ADDENDUM #1

RFP/RFQ # 7459230

TITLE: SOUTH BULKHEAD REPLACEMENT & SITE IMPROVEMENTS, PHASE I, DEM

Addendum No. 1
January 31, 2013
Galilee South Bulkhead – Phase I
Pier 3 Reconstruction
Page 1 of 3

SITE ACCESS PLAN SK-1
SHEET 1 OF 1

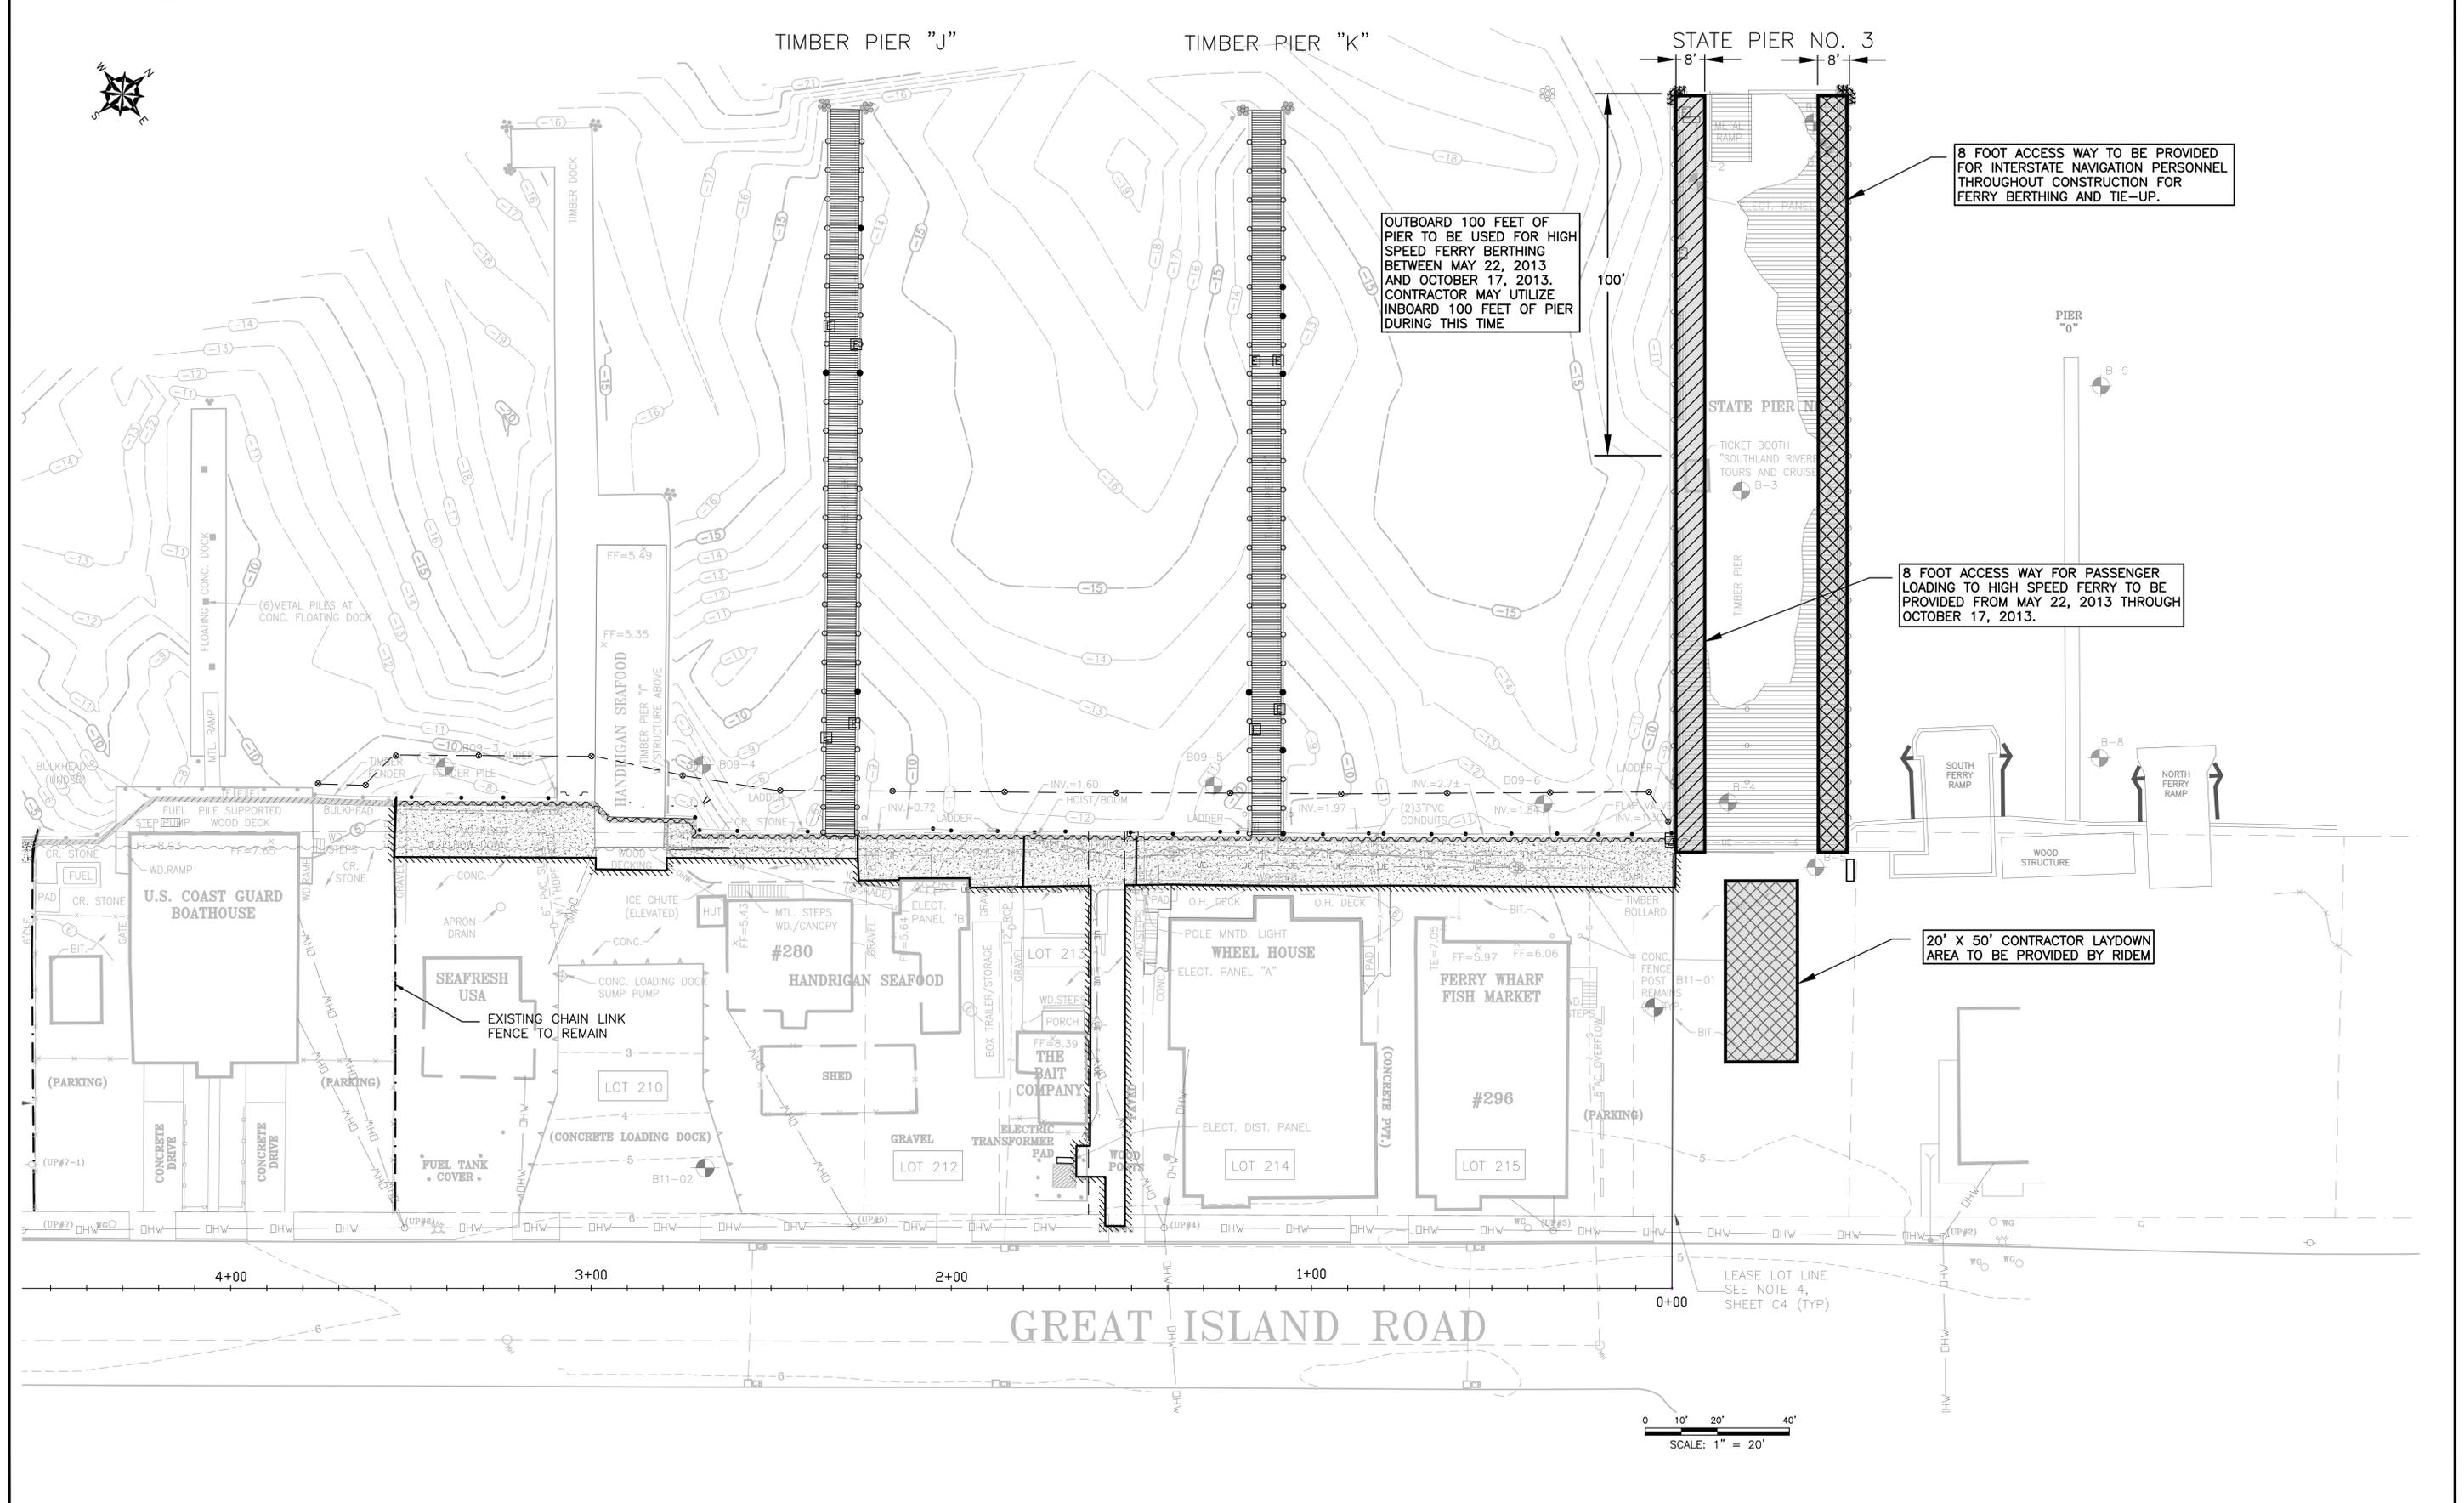
1. The project completion target date is May 22nd when the High Speed Ferry arrives. This ferry will berth on the south side of the pier, and will arrive on May 22, 2013 and begin service to Block Island on Memorial Day weekend. If work is not completed at this time, as a minimum the ferry will need 100 feet of clear space on the south side to berth, and a minimum 8-foot wide safe access way on the pier for passenger loading and unloading, including aluminum gangways if needed. Additionally, an 8-foot wide continuous access way must be maintained on the north side of the pier for Interstate Navigation personnel to tie up the Block Island Ferry. The access requirements are shown on Drawing SK-1 included in Addendum 1.

2. Paragraph 1.5.G of Specification Section 010015 “Contractor’s Use of the Premises” shall be replaced with the following:
 - G. The Block Island Ferry will be using the northern-most 8’ bay throughout construction so the ferry can tie up and dock throughout the day and throughout the construction period. Construction work must accommodate the ferry on the north side of the pier. The existing cleats are to remain for the ferry. The southern-most 8’ bay must be available for the High Speed Ferry from May 22 to October 1 for passenger loading, ticketing, and docking. The contractor must provide safe travel for passengers loading and unloading onto the High Speed Ferry during those times and must install temporary fencing as needed. The High Speed Ferry will only need to access the southwestern 100’ of the pier between May 22 and October 1st.

OUTBOARD 100 FEET OF PIER TO BE USED FOR HIGH SPEED FERRY BERTHING BETWEEN MAY 22, 2013 AND OCTOBER 17, 2013. CONTRACTOR MAY UTILIZE INBOARD 100 FEET OF PIER DURING THIS TIME
